PINE VIEW ESTATES  
GRADING & EROSION  
CONTROL PLAN

PCD FILE NO: SP-20-019

GRADING & EROSION CONTROL PLAN

SHEET: 2 OF 3

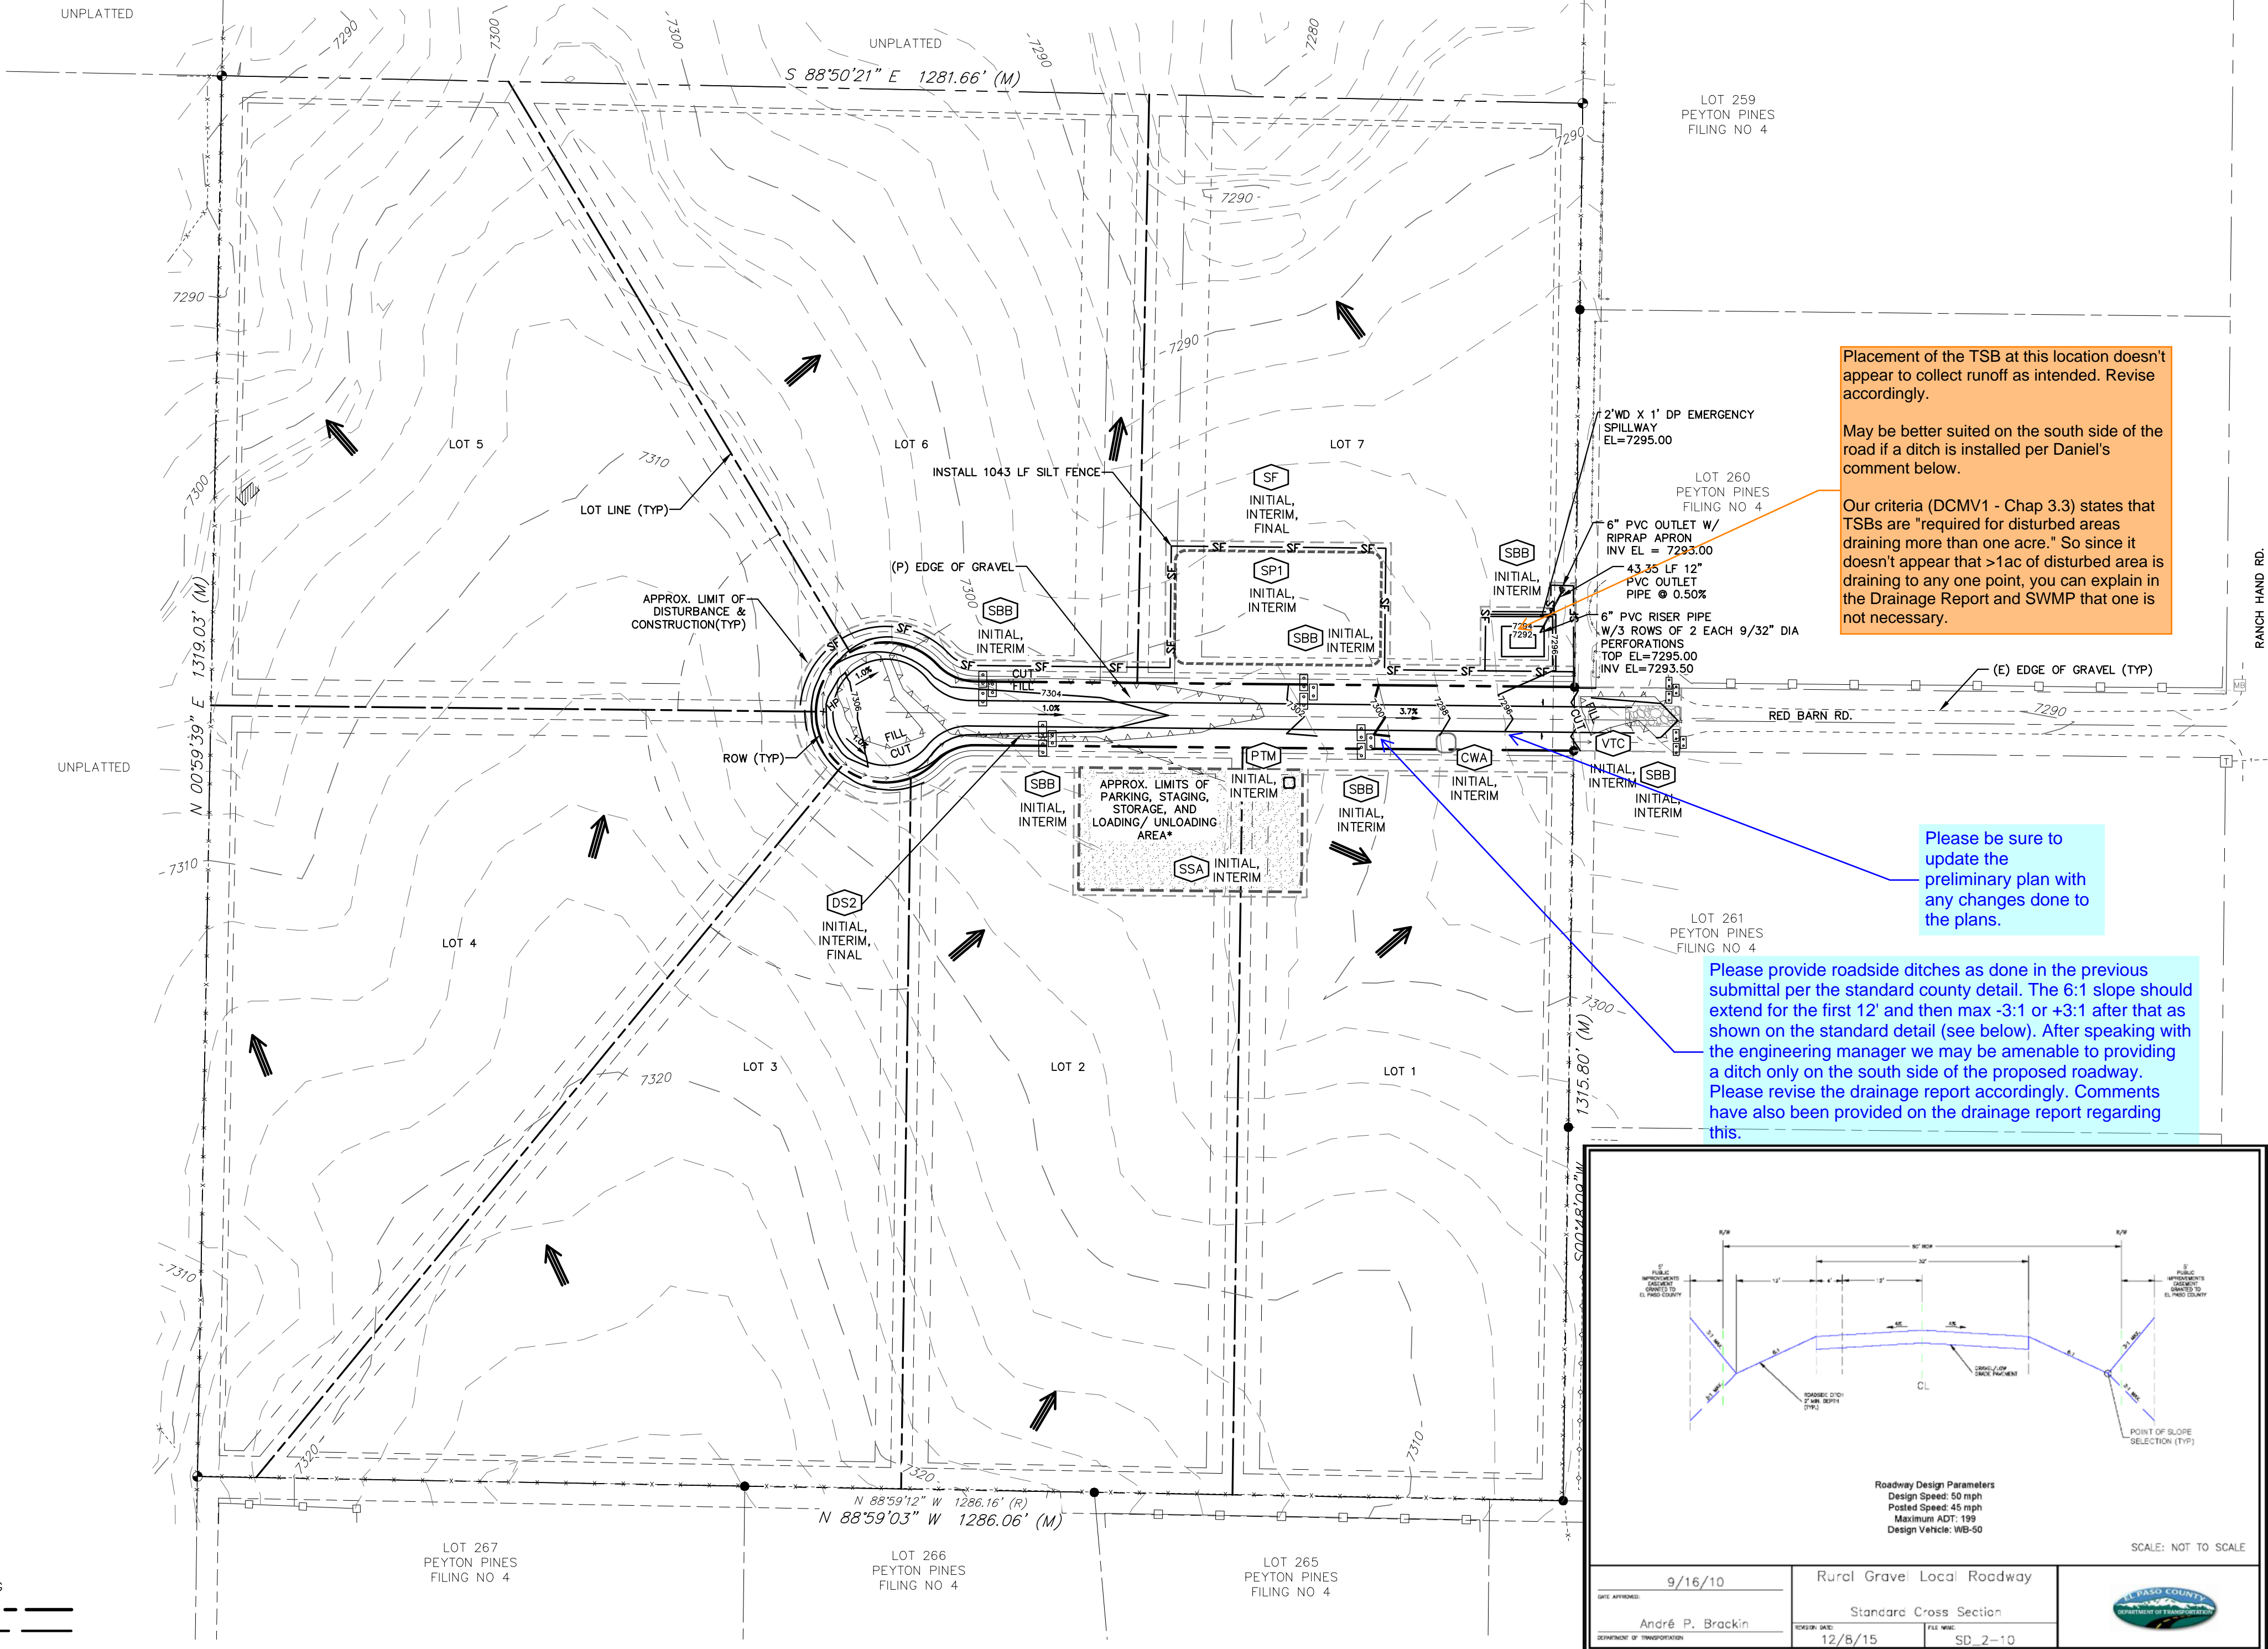
Placement of the TSB at this location doesn't appear to collect runoff as intended. Revise accordingly.

May be better suited on the south side of the road if a ditch is installed per Daniel's comment below.

Our criteria (DCMV1 - Chap 3.3) states that TSBs are "required for disturbed areas draining more than one acre." So since it doesn't appear that >1ac of disturbed area is draining to any one point, you can explain in the Drainage Report and SWMP that one is not necessary.

Please be sure to update the preliminary plan with any changes done to the plans.

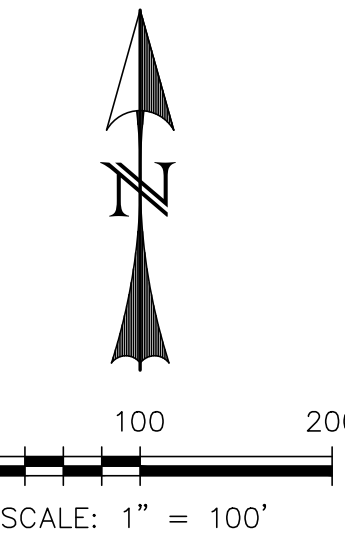
Please provide roadside ditches as done in the previous submittal per the standard county detail. The 6:1 slope should extend for the first 12' and then max -3:1 or +3:1 after that as shown on the standard detail (see below). After speaking with the engineering manager we may be amenable to providing a ditch only on the south side of the proposed roadway. Please revise the drainage report accordingly. Comments have also been provided on the drainage report regarding this.
